QUESTIONS-ANSWERS-CLARIFICATIONS

SAFE ROUTES TO SCHOOL SAFETY AND CONNECTIVITY IMPROVEMENTS

CITY PROJECT NO. WT19005/FEDERAL PROJECT NO. ATPCML-5008(189)

February 28, 2024 Posting

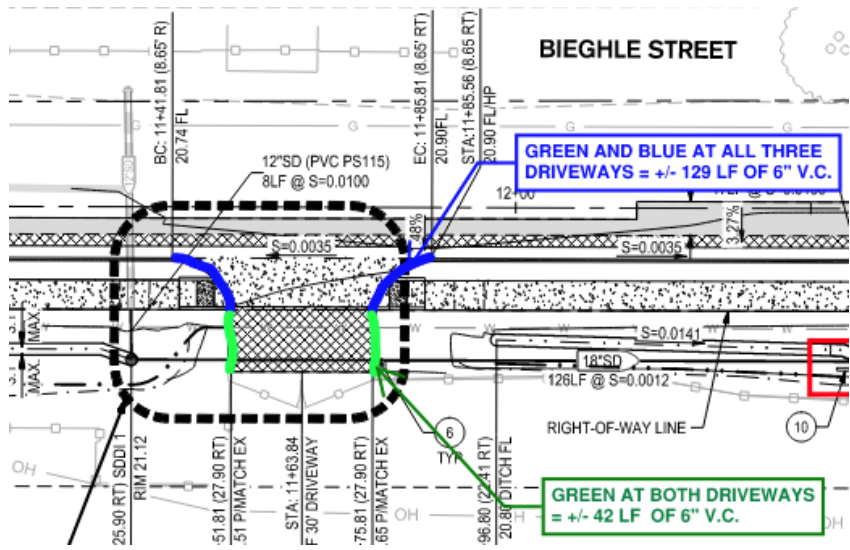
Answer: Hydroseed may be paid through Erosion Control lump sum item. Section 21 of Caltrans specifications for erosion control referenced in our spec includes items for hydroseed.
6. Question: Does note #6 on C4.44-45 pertain to Bid Items #49, if so please clarify where the additional quantity is located as only +/-40' is on the drawings and the retaining curb at the ramps should be paid as ramps.

Answer: Yes note 6 is for a 6" vertical curb (Item #49). Below is a summary of what we have on Bieghle Street +/-42LF for just the vertical curb on the driveway plan south of the curb ramp (Green). If the driveway vertical curb was included around the driveway flare for all the driveways, we have +/-129 LF of vertical curb (Blue + Green). Since we have items for the driveway, we could see this being reduced to the +/-42LF.

GREEN AND BLUE AT ALL THREE DRIVEWAYS = +/- 129 LF OF 6" V.C.

GREEN AT BOTH DRIVEWAYS = +/- 42 LF OF 6" V.C.
